Product Change Notification / ASER-06ZMCM207

CCB 4630 Final Notice: Qualification of STA as an additional assembly site for selected LAN9303, LAN9210 and LAN9211 device families available in 56L VQFN (8x8x0.9mm) package.

Pre and Post Change Summary

PCN #: ASER-06ZMCM207

Lead frame Comparison

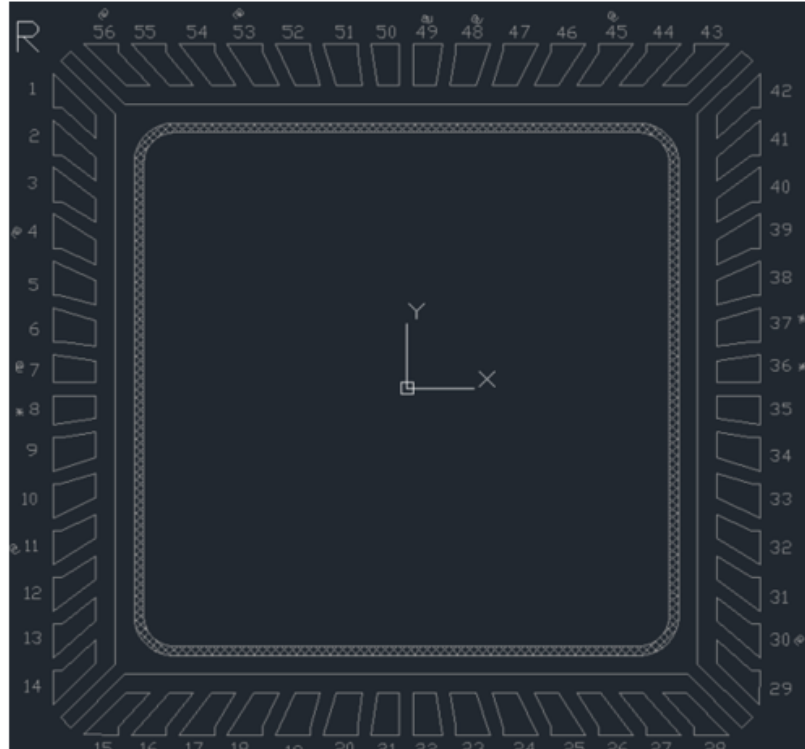
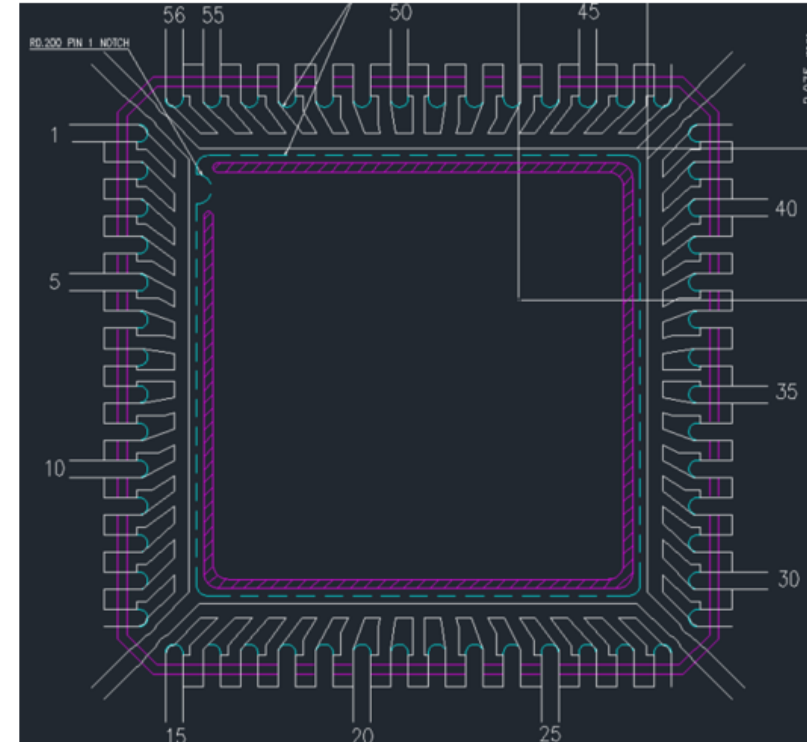
Wire material	PdCu	Au	PdCu	Au	CuPdAu
Die attach material	EN-4900F		EN-4900F		8290
Molding compound material	G631B		G631B		G700E
Lead frame material	C194		C194		C194
Lead frame lead-lock	No		No		No
	See Pre and Post Change Summary for comparison.				
Lead frame paddle size	240x240 mils		240x240 mils		236x236 mils
